**WLA4 - Retrofitting Heat Shield (Workshop Campaign)**

Revision: This bulletin replaces bulletin Group 1 19/20 WLA4, dated April 30, 2020.

Vehicle Type: **911 Turbo (991)**

Subject: **Heat shield on rear cross member**

*Installation position of heat shield*

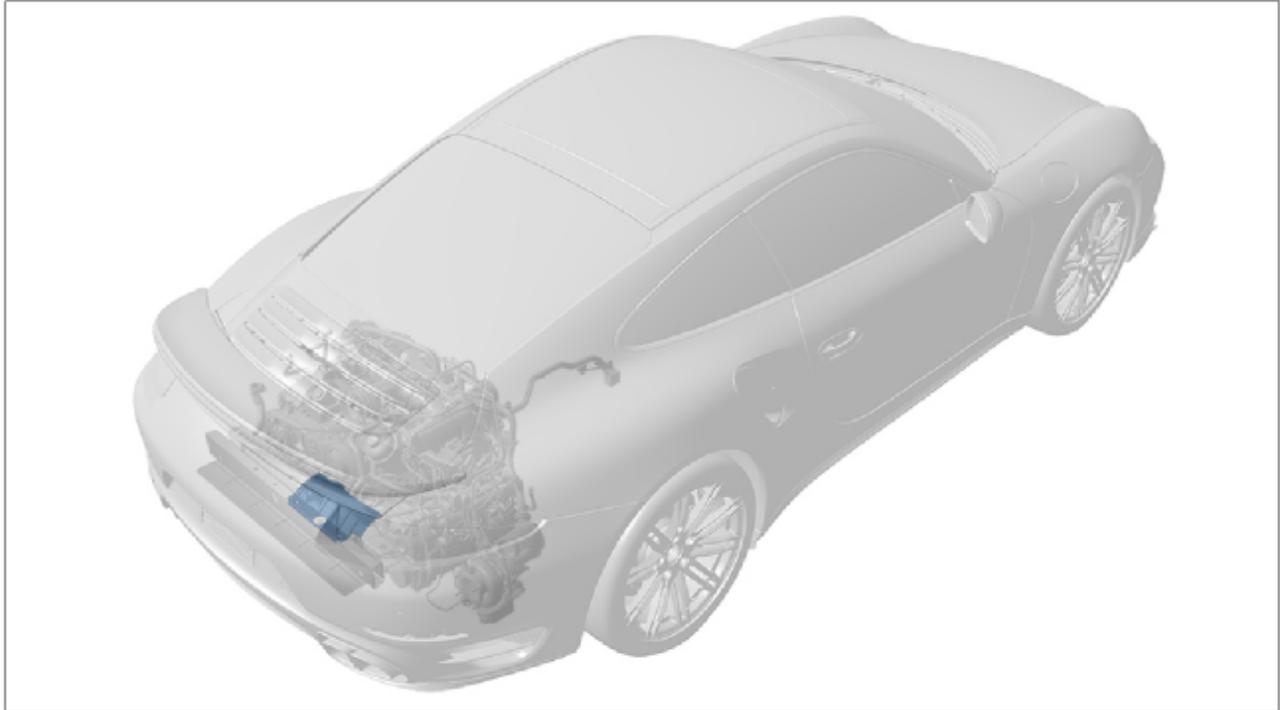
Remedial Action: Retrofit heat shield on rear cross member in the engine compartment. This shield may help to prevent any foreign objects or materials from touching exhaust-carrying or hot components in the engine compartment.
